DESIGN REVIEW COMMITTEE AGENDA

a) Z0083-23-D: Application for a Design Review permit to construct a new 15,360 square foot public library and to renovate an existing building (formerly Concord School) into a community center. ‡	Melissa Lord MLord@clackamas.us 503-742-4504
--	--

RECOMMENDATION TO THE DESIGN REVIEW COMMITTEE

File No. Z0083-23-D

A3.10

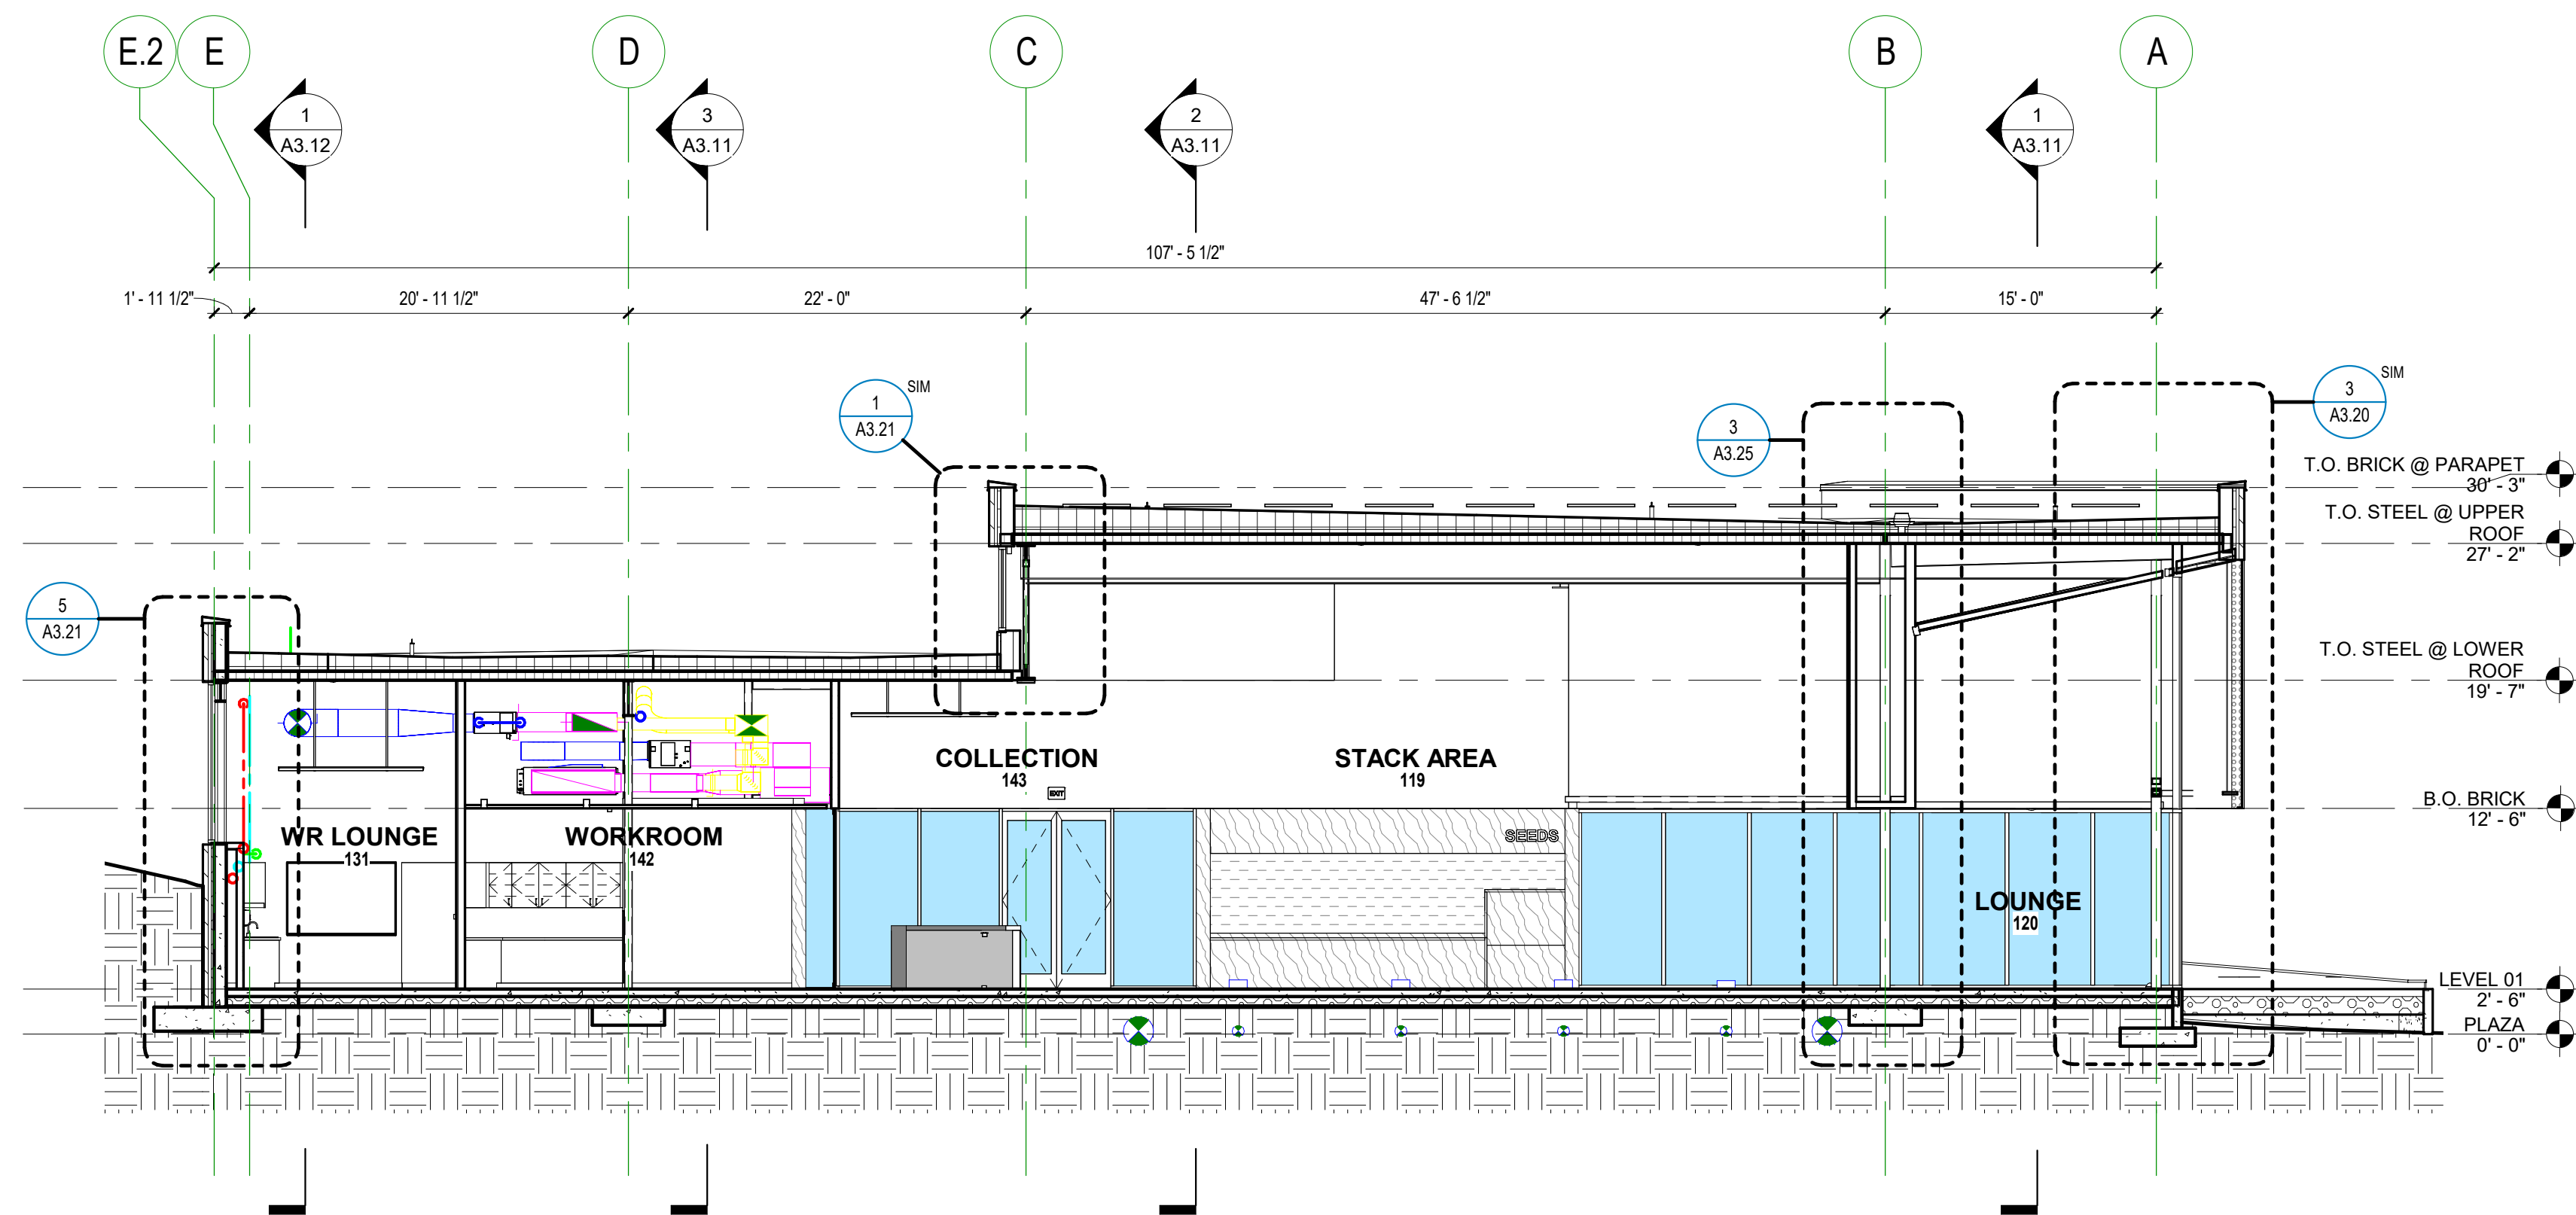
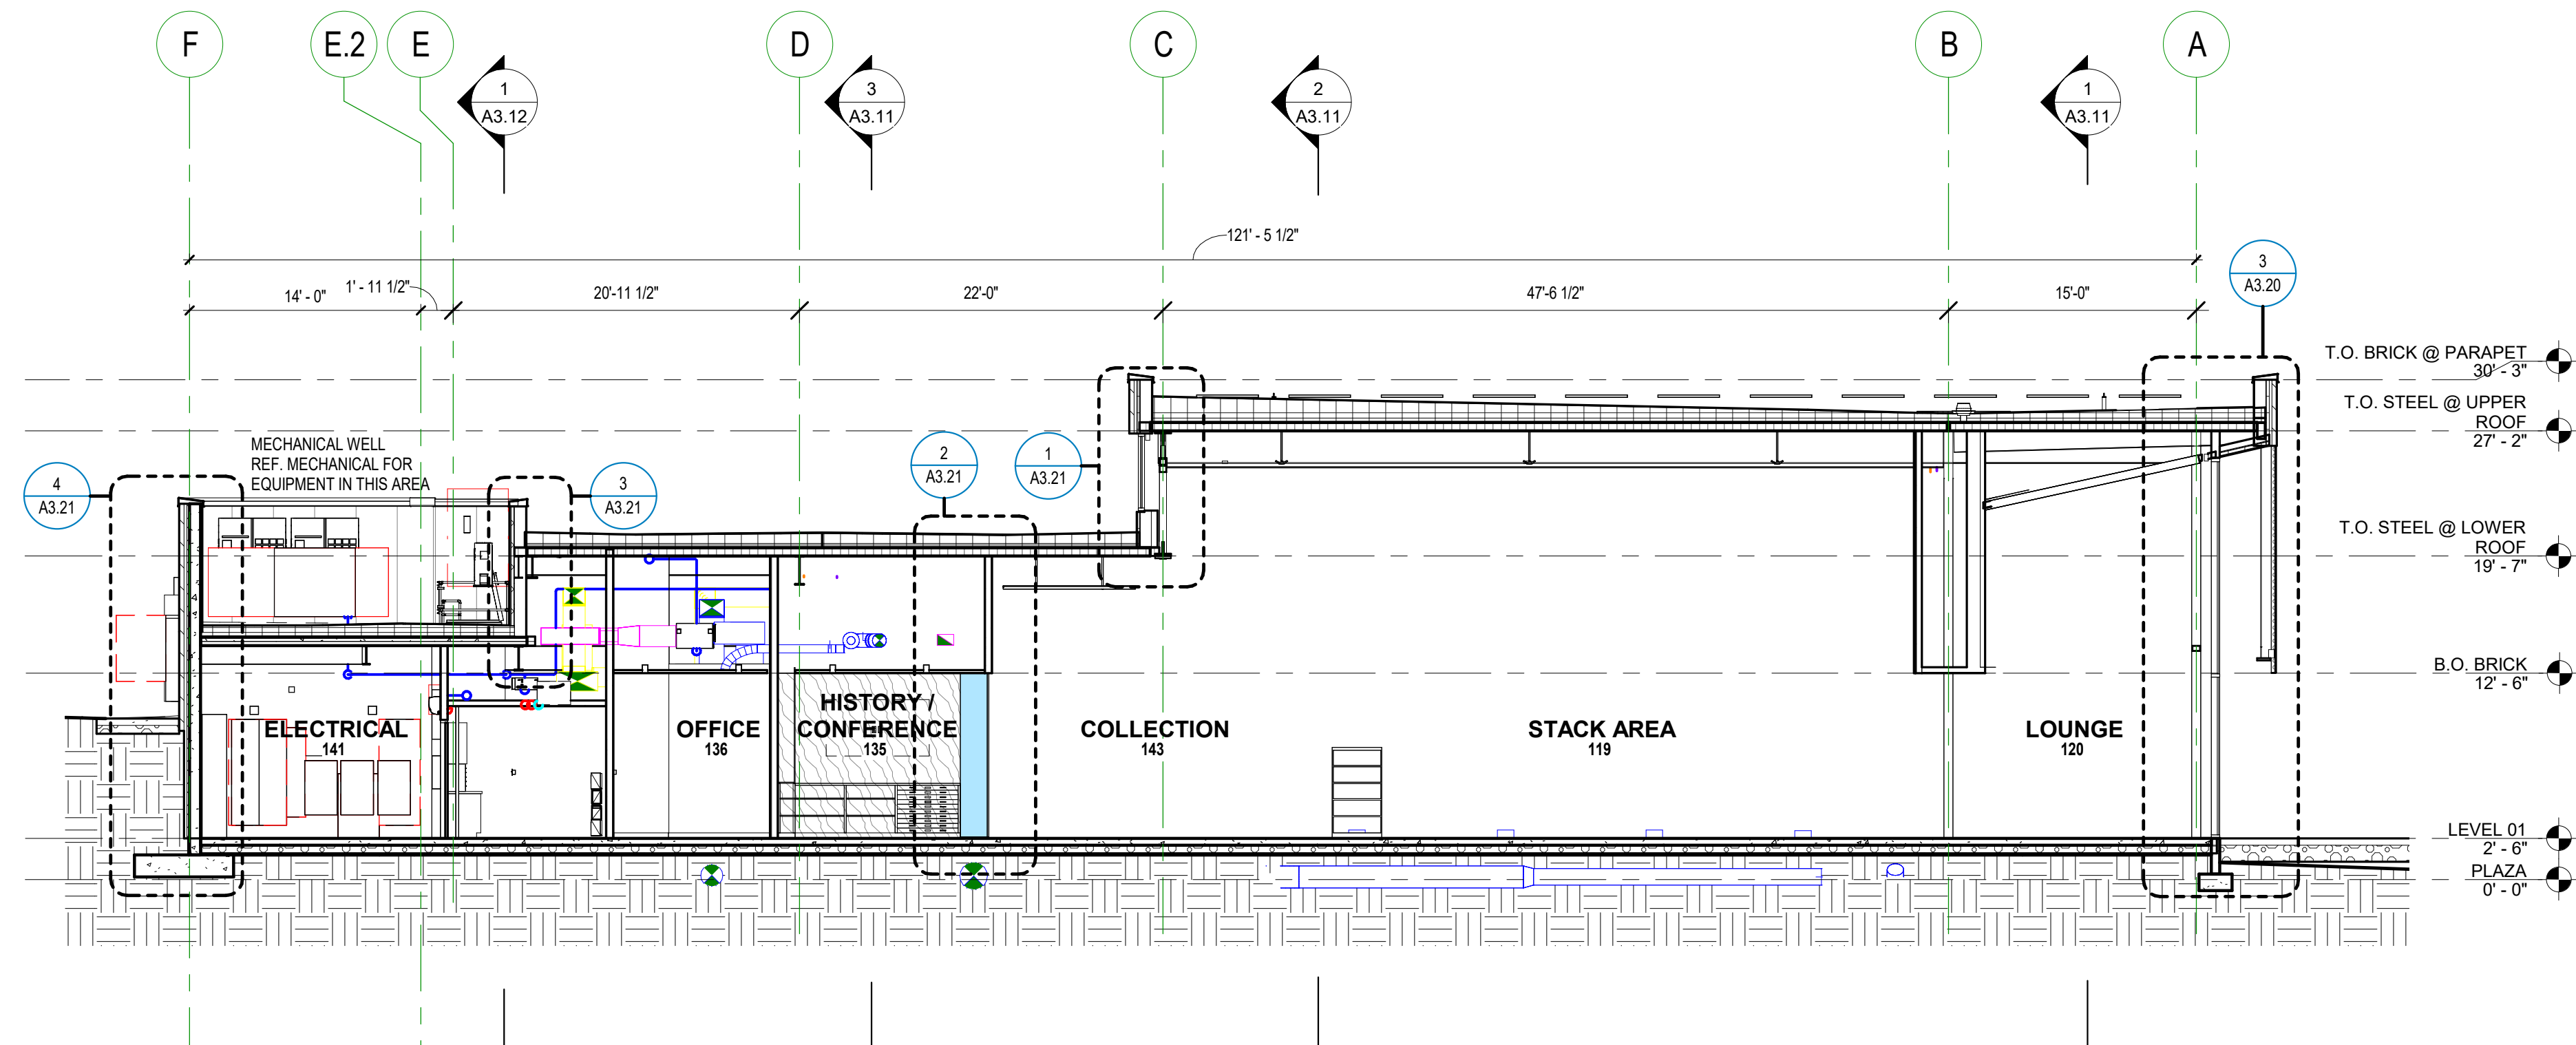
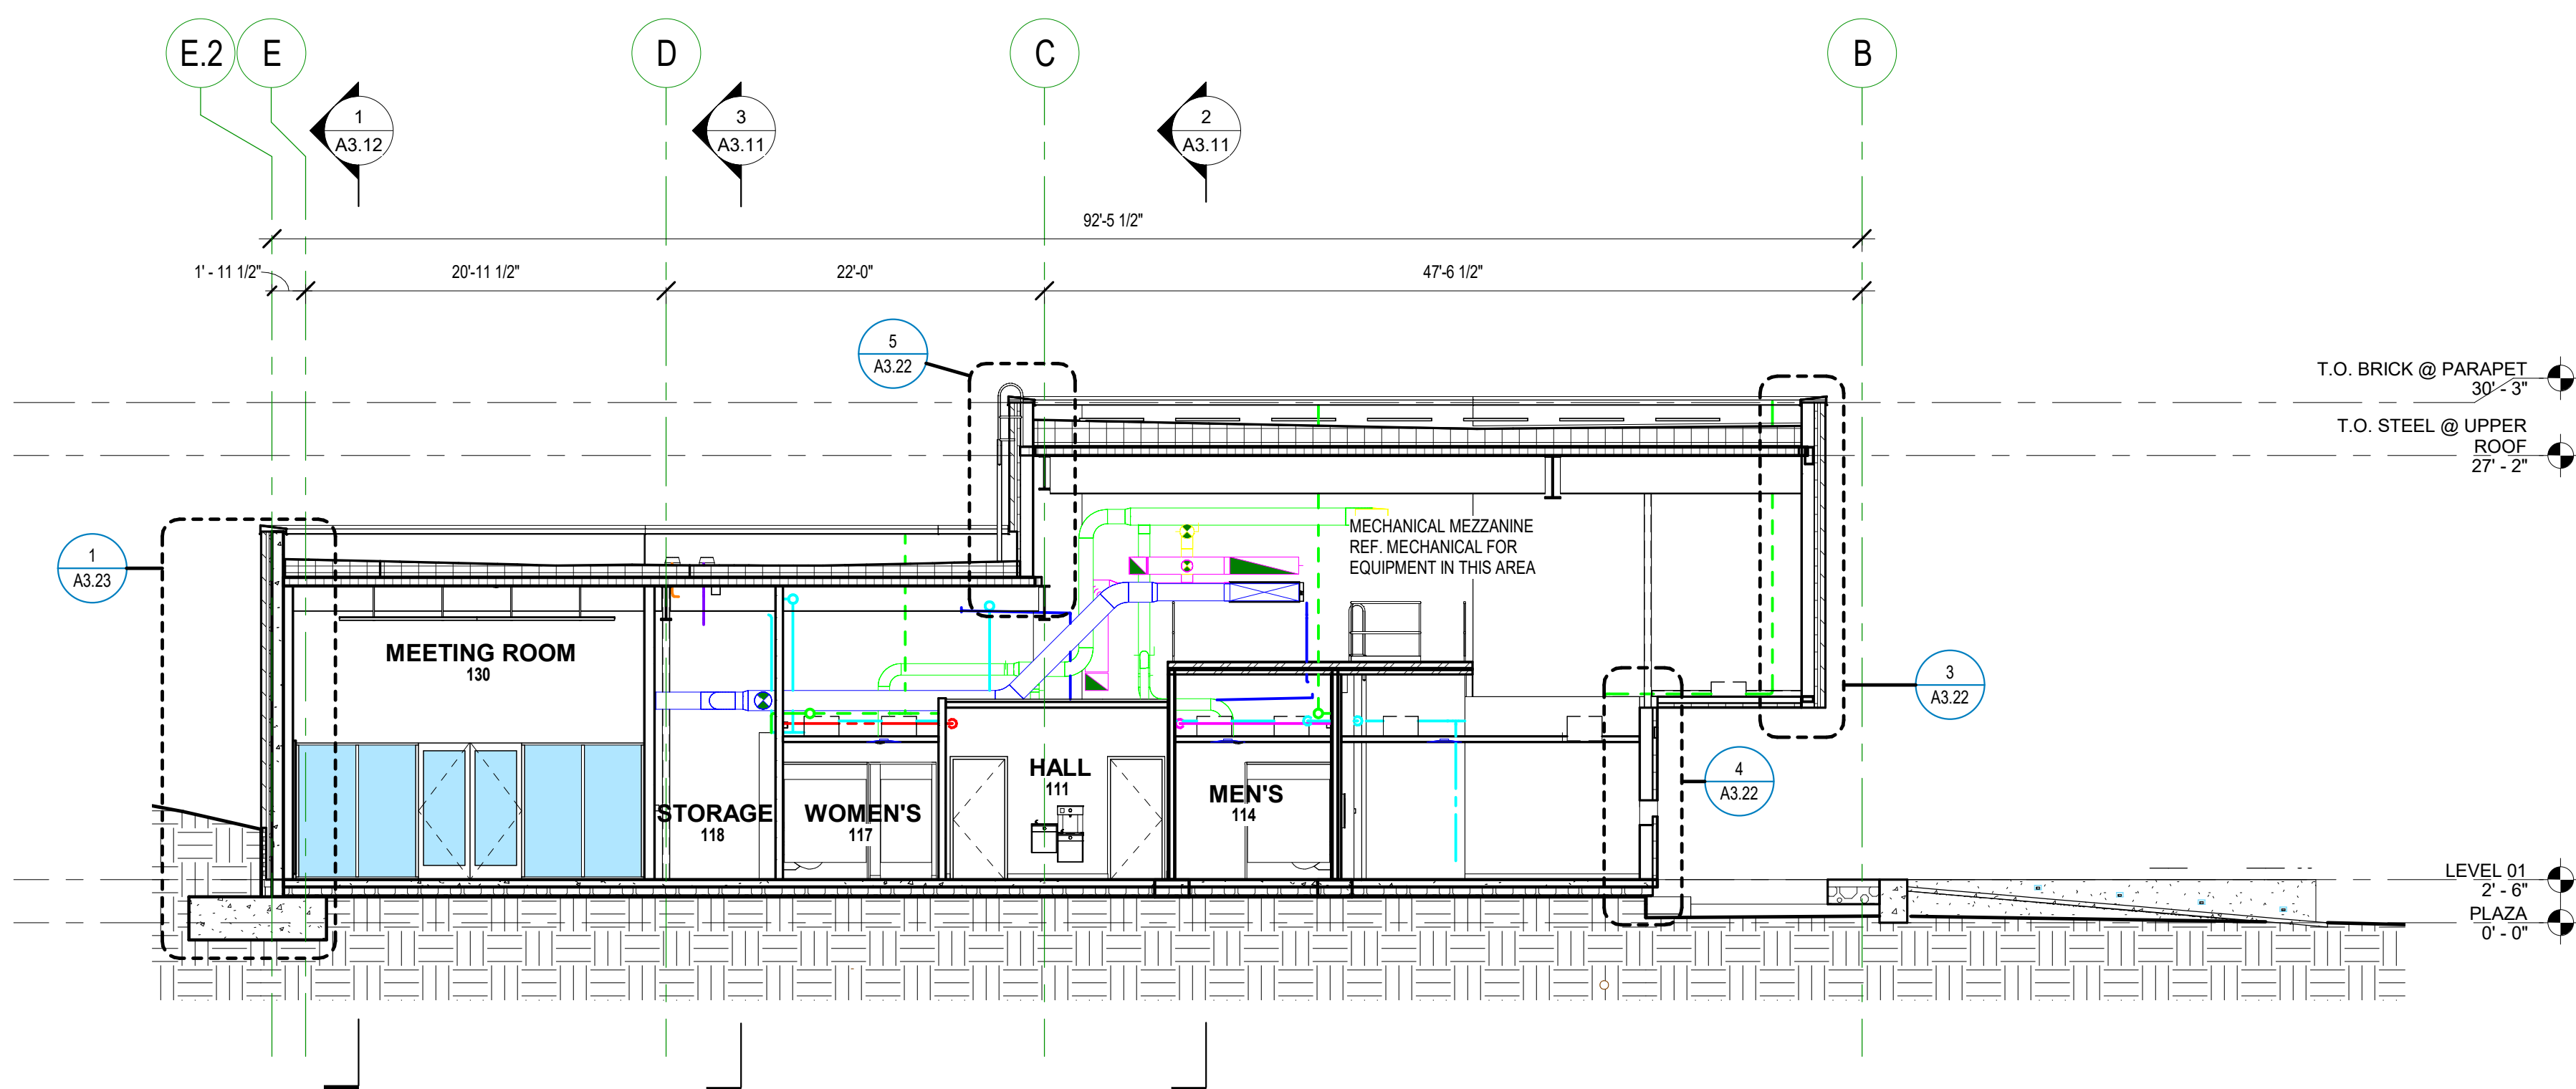
The new rooftop equipment on the library will be placed into a recessed well that will be screened by a parapet to ensure that none of the equipment is visible, as demonstrated on the plans submitted, including Sheet A3.10. The applicant's narrative states that "new mechanical units will be added to the community center roof that will be smaller than the existing units and will be pushed back from the roof edge as far as possible to obscure them from sight. Two new ground-mounted mechanical units will be placed on the east side (rear) of the community center and will be partially screened by the new trash enclosure and existing building."
